Kings Quarry Expansion – Stage 2 Fast Track BUN60450001 / WAT60450003 - Groundwater Diversion and Dewatering

**From:** Andy Samaratunga – Senior Specialist, Coastal and Water Allocation, Planning and Resource Consents Department, Auckland Council

**Date: 27 June 2025**

Figure 1: Stage 2 Quarry Extension Plan (Source: Appendix 12 of the AEE)

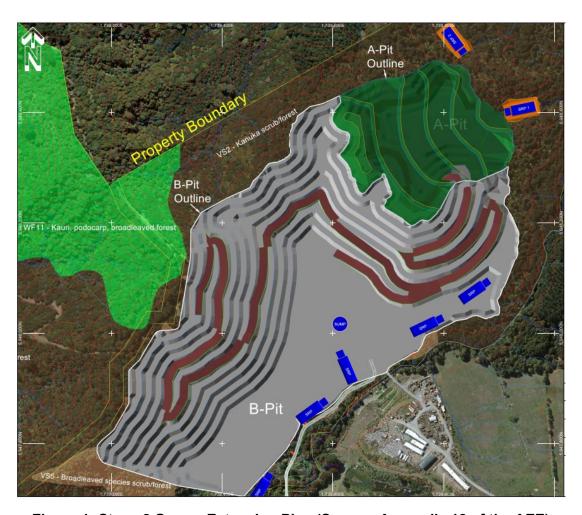
The quarry activities will be undertaken in a staged manner. In the first five years, it is proposed to excavate approximately 6.1ha for the formation of A-Pit. The resulting overburden will be removed and backfilled into the lower sections of the fill site, as the excavation progresses.

The main quarry pit (B-Pit) will be excavated from year 6, and will span to 26.46ha in the 45-year lifetime. 1.2 million BCM of overburden from the B-Pit will be removed and deposited along the haul road in the A-Pit throughout the lifetime, and approximately 8.0 million BCM of rock product will be extracted from the B-Pit overall. The final proposed quarry excavation level is RL 44.0m. The quarry has been designed to vertically avoid the Waitoki Stream to avoid significant stream depletion. A plan of the proposed quarry is shown in Figure 1.
